UNITED STATES PATENT AND TRADEMARK OFFICE

APPLICATION NO.	FILING DATE	FIRST NAMED INVENTOR	ATTORNEY DOCKET NO.	CONFIRMATION NO.
10/006,658	12/10/2001	Sung Pyo Hong	0630-1388P	2199

Office Action Summary

DETAILED ACTION

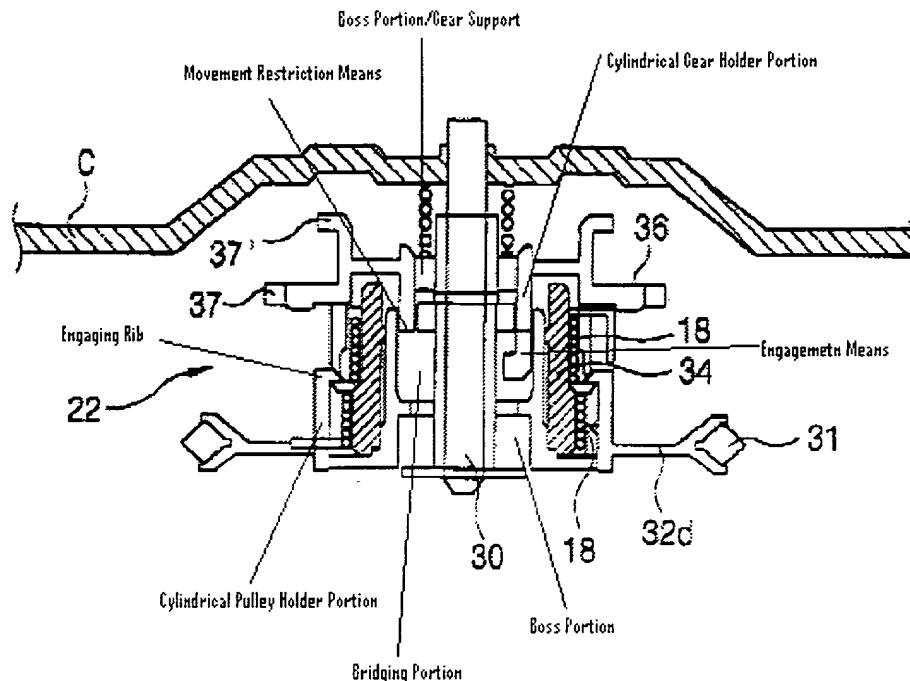
Claims 1-3, 8, 10-15 and 18, as understood, are rejected under 35 U.S.C. 102(b) as being anticipated by the acknowledged prior art.

The acknowledged prior art discloses a central shaft (30), a pulley (32), an up down gear (36), a clutch spring (18 or 18'), a large gear (37) and a small gear (37').
